## TECHNICAL SERVICE BULLETIN

<b>NUMBER</b>	<b>16TSB-37</b>	<b>TYPE</b>	<b>UPDATED SERVICE ALERT</b>		
<b>TITLE</b>	<b>V-PLOW WINGS NOT ACTING INDEPENDENTLY V-PLOW STRAIGHT BLADE MODE NOT WORKING</b>				
<b>REV</b>	<b>C</b>	<b>ISSUED</b>	<b>12/31/2009</b>	<b>REVISED</b>	<b>9/7/2010</b>
<b>AFFECTS</b>	VX SERIES PLOWS - SEE BELOW FOR UPDATED INFORMATION				
<b>INFORMATION</b>	A MANUFACTURING DEFECT HAS BEEN IDENTIFIED CAUSING SOME V-PLOW HPUS TO HAVE AN UNACCEPTABLE LEVEL OF CONTAMINATION CAUSING THE S2 AND S3 VALVES TO INTERMITTENTLY STICK. WHILE THE SOURCE OF THE CONTAMINATION HAS BEEN FOUND AND ELIMINATED, SNOWDOGG ENGINEERING HAS REDESIGNED THE TOP BLOCK OF THE POWER UNIT TO ELIMINATE THE S2 AND S3 SPOOL VALVES THAT WERE SENSITIVE TO THE ISSUE. THEY HAVE BEEN REPLACED BY POPPET VALVES.				
<b>IDENTIFICATION</b>	WHEN LEFT EXTEND IS PRESSED, PLOW SCOOPS AND ANGLE LEFT DOESN'T WORK AND/OR WHEN RIGHT EXTEND IS PRESSED, PLOW SCOOPS AND ANGLE RIGHT DOESN'T WORK

## 3016553 VX HYDRAULIC KIT

Kit to upgrade 16152000 to 16152000B VX hydraulic power unit

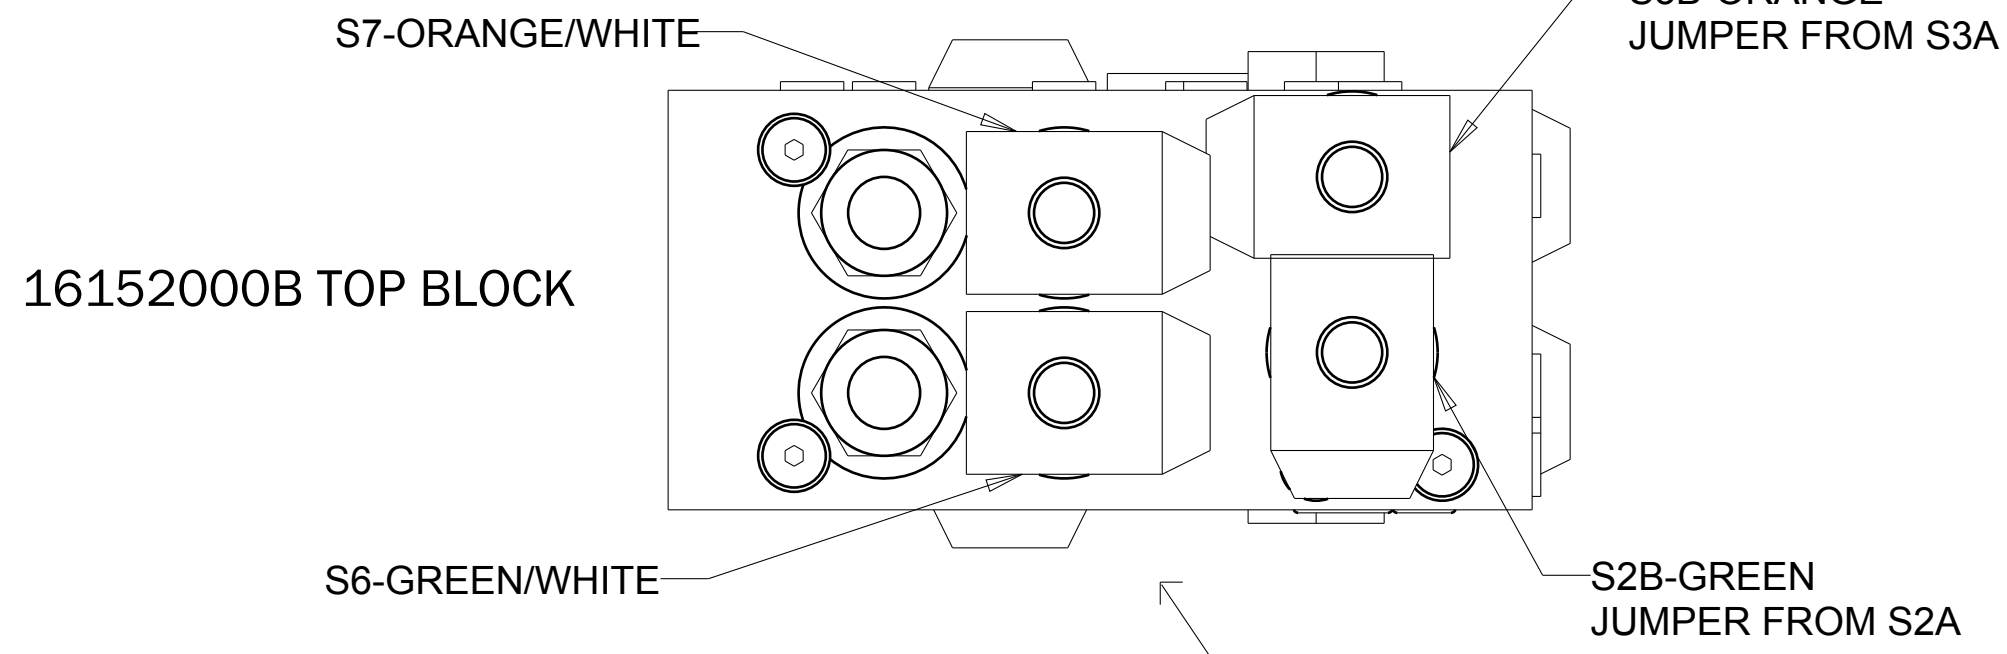
The 16152000 power unit has 9 coils total.

The 16152000B power unit has 11 coils total

EXISTING 16152000 UNIT

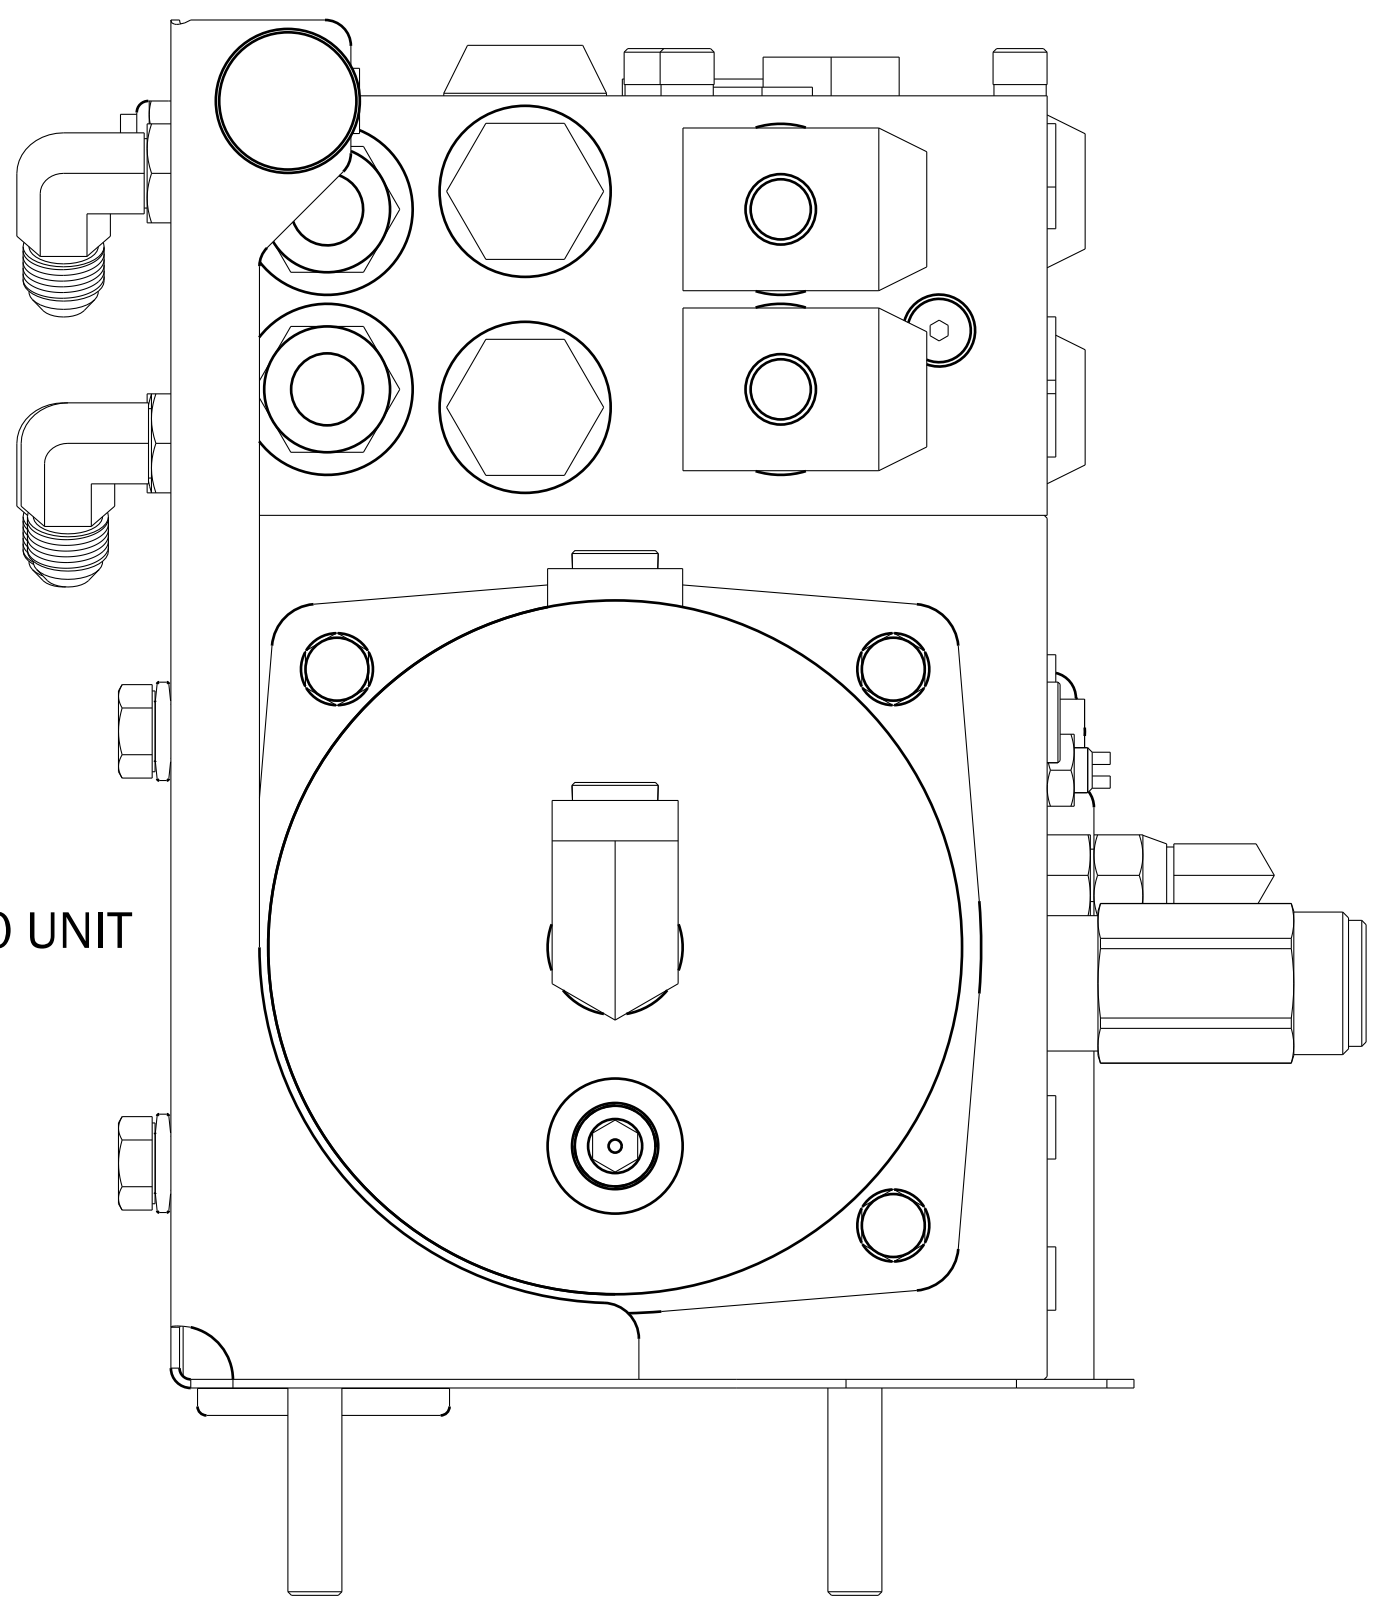
7. Assemble the 90 degree fittings to the rear (in the same orientation as before) and secure the hoses.
8. Reconnect the colored and black wires to the coils on the new top block as shown below. Note that S7 and S6 have been moved over in the new block – be sure to connect to the proper coils.

9. The S2A and S2B coils should already be connected to each other with jumpers.
10. The S3A and S3B coils should already be connected to each other with jumpers.
